**From:** [Patrick McKeegan](#)  
**To:** [Hanna Veal](#); [CK@KeithTribe.com](mailto:CK@KeithTribe.com)  
**Subject:** Re: 107 E. 40th St. CUPFY2023-0010  
**Date:** Monday, July 31, 2023 8:32:25 PM  
**Attachments:** [image002.png](#)  
[image003.png](#)  
[image004.png](#)  
[image005.png](#)  
[SITE PLAN VER 2 7-31-23.pdf](#)  
[LANDSCAPE PLAN VER 1 7-31-23.pdf](#)  
[LANDSCAPE PLAN VER 2 7-31-23.pdf](#)  
[SITE PLAN VER 1 7-31-23.pdf](#)

Hanna - Attached are two plans that address the "yellow" staff comments.

# 107 E. 40TH STREET CUP LS PLAN - REV 2

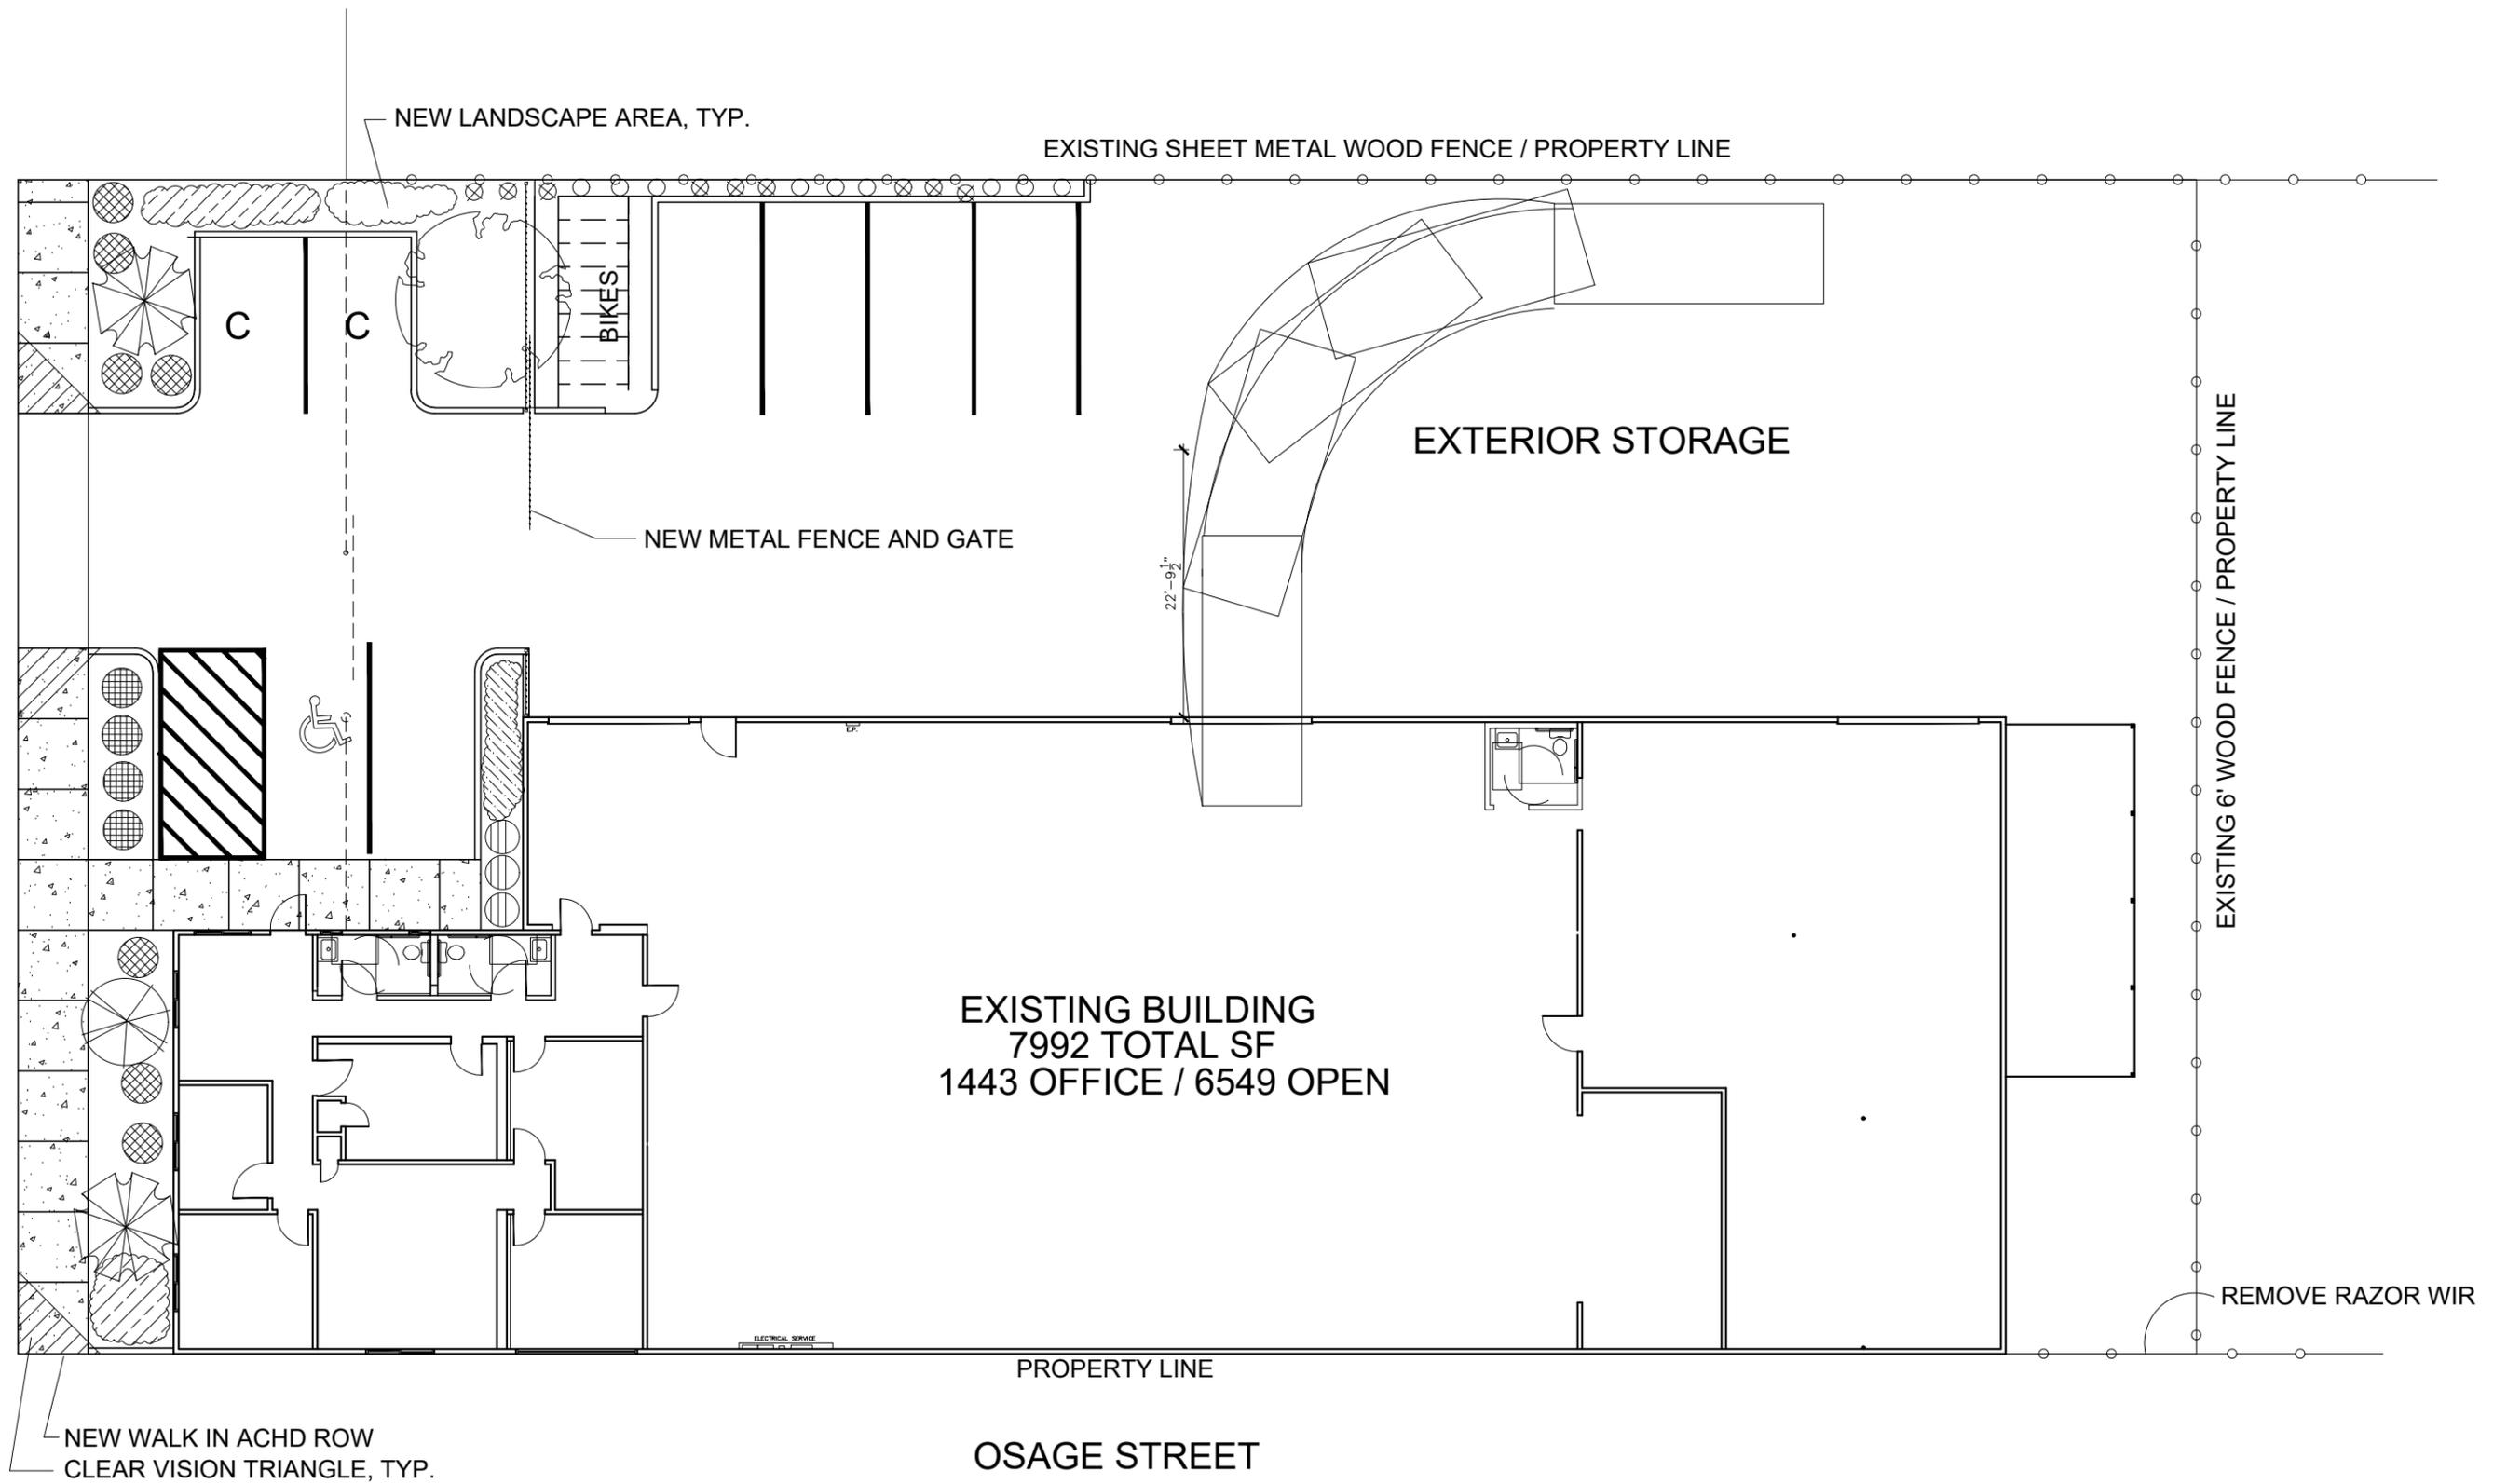
Rev 2 is based on the plan we submitted with the attached sidewalk. The property to the SW has an attached sidewalk except for a short section around the power pole. Other properties NE on 40th Street that have sidewalks are attached as well.

# 107 E. 40TH STREET CUP LS PLAN - REV 1

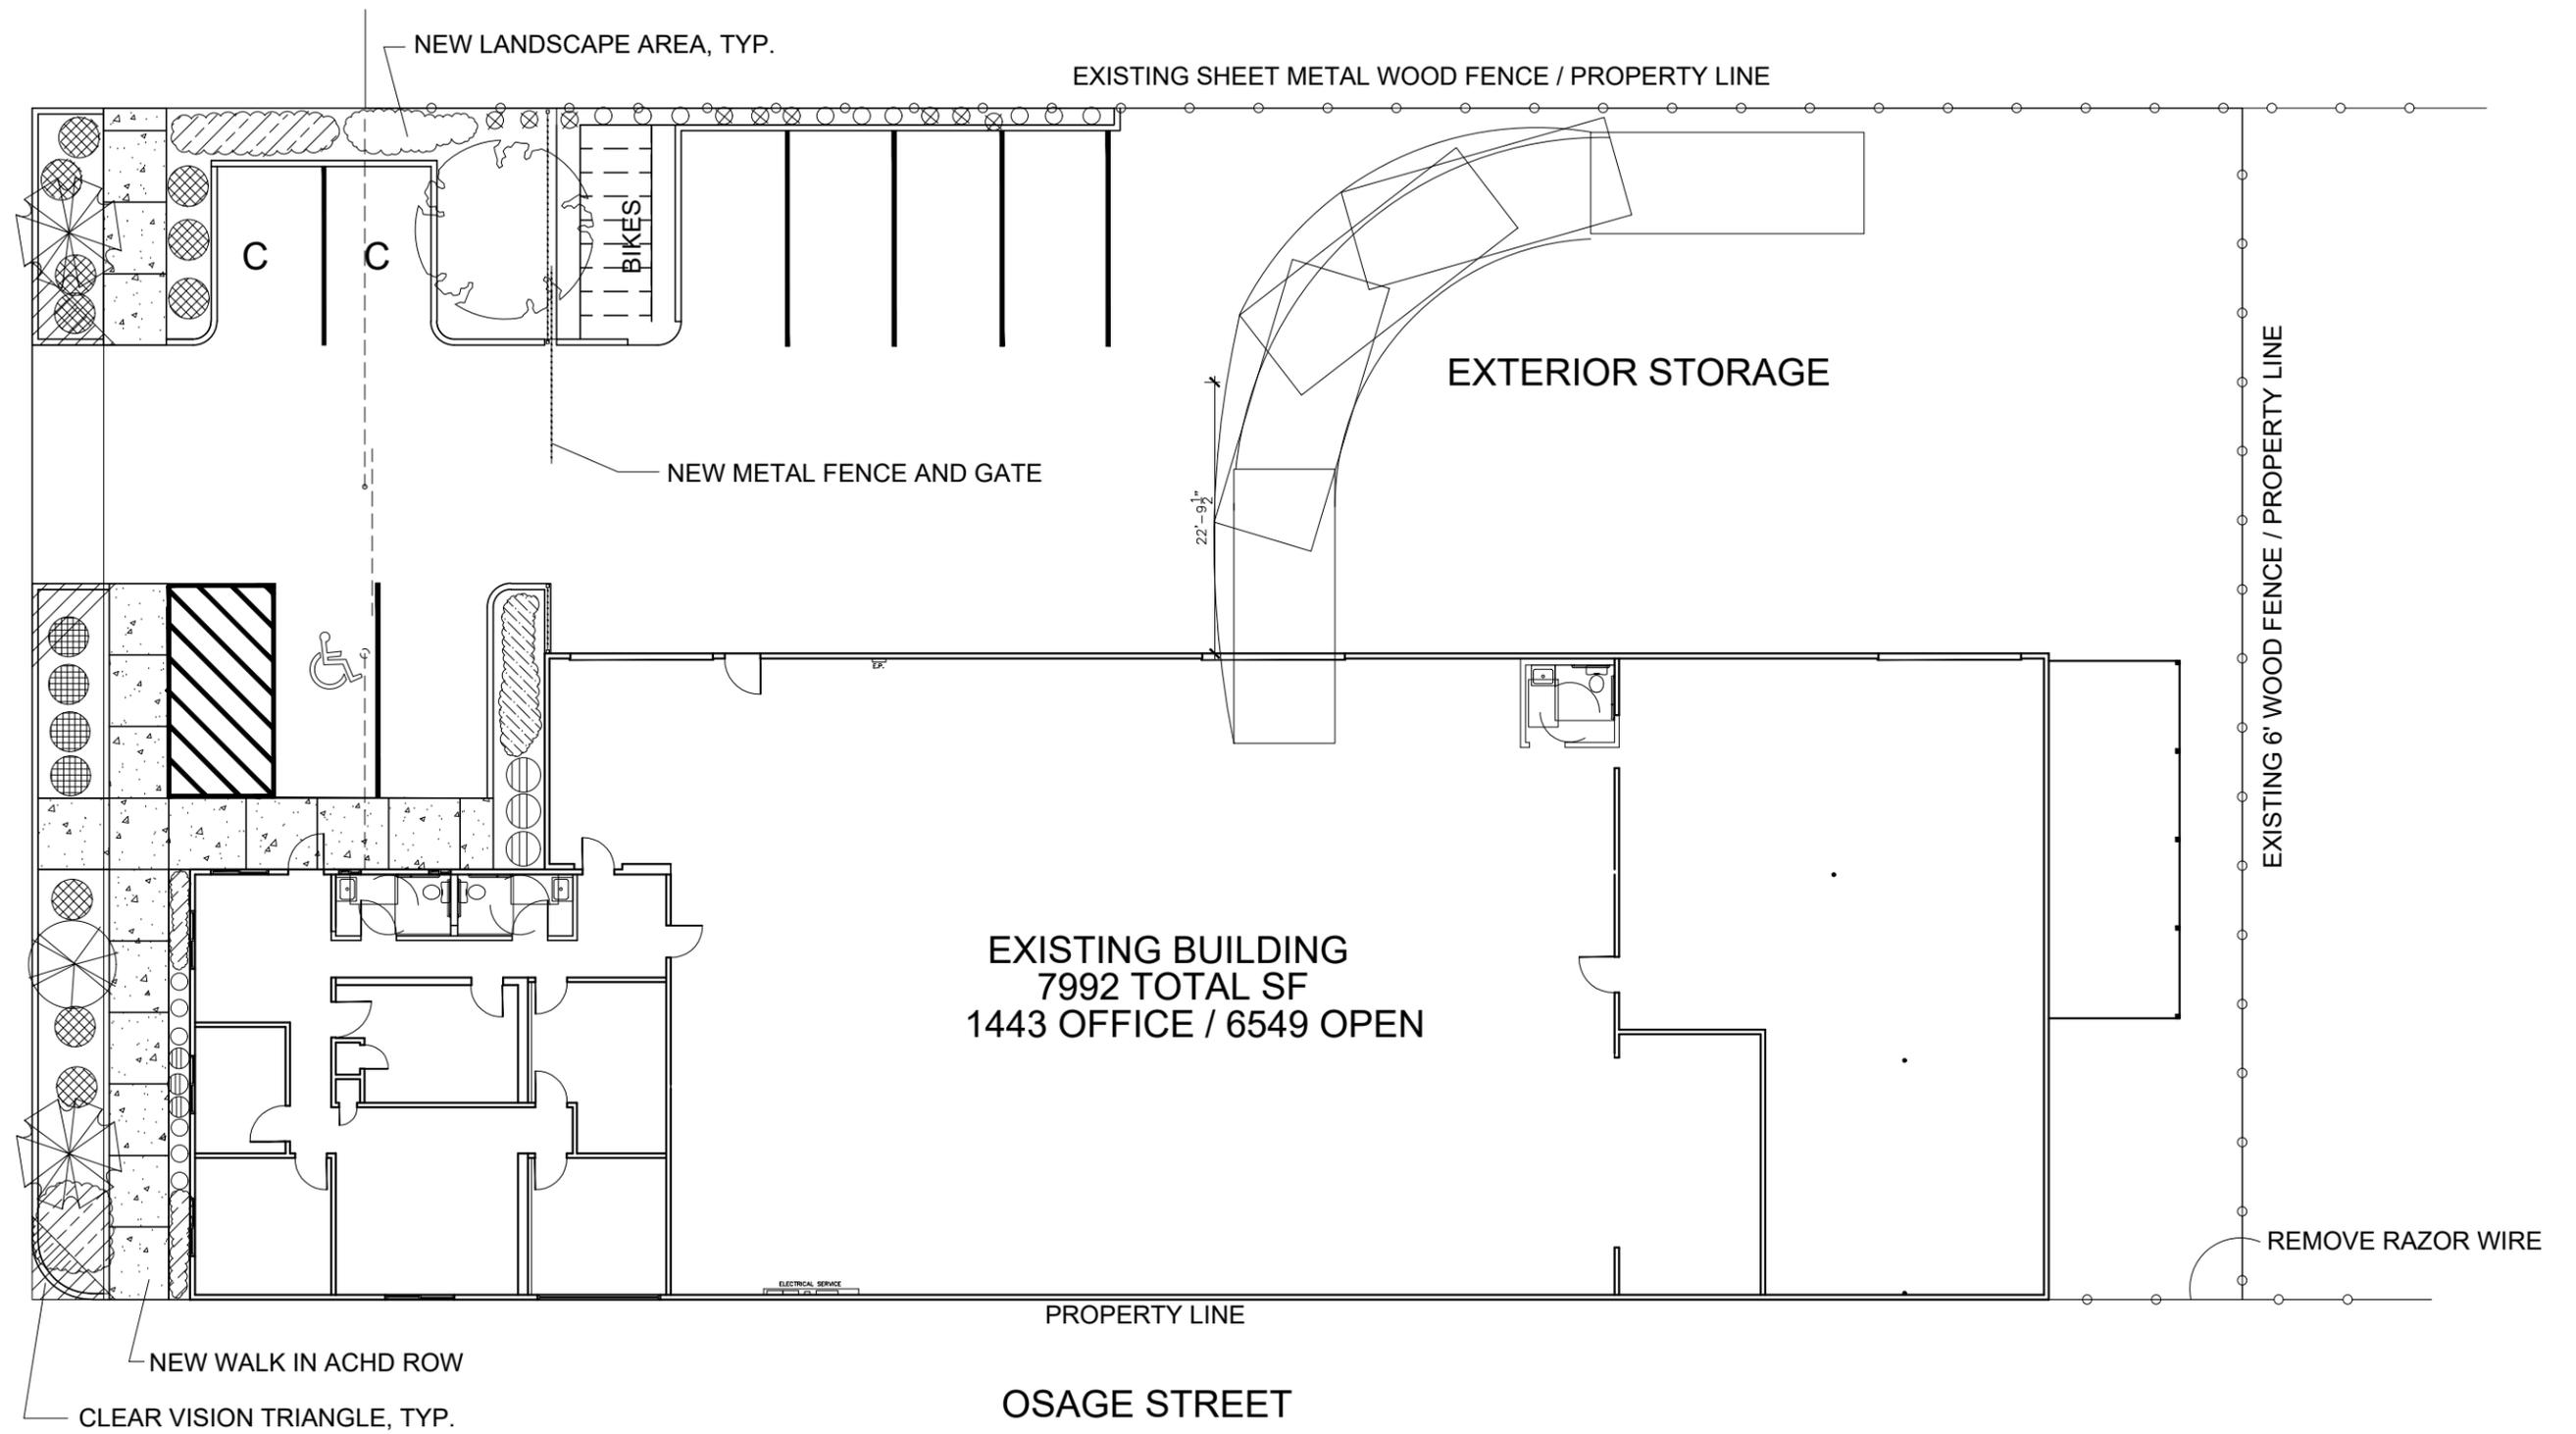
Rev 1 moves the sidewalk inward to allow for a 6'-3" landscape strip, five foot side walk and two foot landscape strip next to the building. I do not like to die sidewalks up to a building, over time water, snow and ice intrude, freeze and damage the walk and building foundation. It also dresses up the building base.
